DDS- Planning & Zoning: Plan Review Application

Special Permit Submission

PKV, LLC
PARKVILLE MARKET
1390 PARK ST. BUILDING
ALTERATIONS
1390 Park St. Hartford, Ct. 06106

drawing title
ROOFTOP FLOOR PLAN

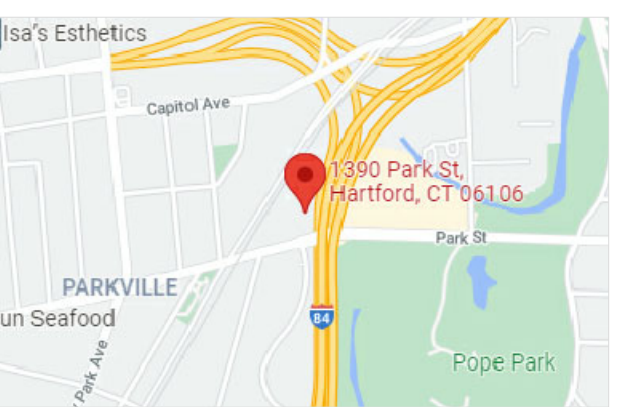
Please confirm hours of operation of the Entertainment Assembly and Drinking Place use.

This space will primarily be in operation for the following:

- During private events, scheduled through our events team in accordance with our current property hours of operation (listed below)
- Additional seating for market patrons during colder months when our patio is closed. The Operating hours in this use case will likely be on Friday evenings, Saturdays and Sundays, when our traffic is highest.
- Entertainment events scheduled by our Events team, within the current Market operating hours.
- Current Market Operating Hours:
 - Monday: 11AM - 8PM
 - Tuesday :11AM - 10PM
 - Wednesday: 11AM - 11PM
 - Thursday: 11AM - 11PM
 - Friday: 11AM - 12AM
 - Saturday: 11AM - 12AM
 - Sunday: 11AM - 8PM

The small outdoor dining area above the first floor of 1390 will be only used for the adjacent food vendors during Market Operating hours.

The Roof Top Lounge on the north end will be used only when the room below is rented for events and will close when the event is over.
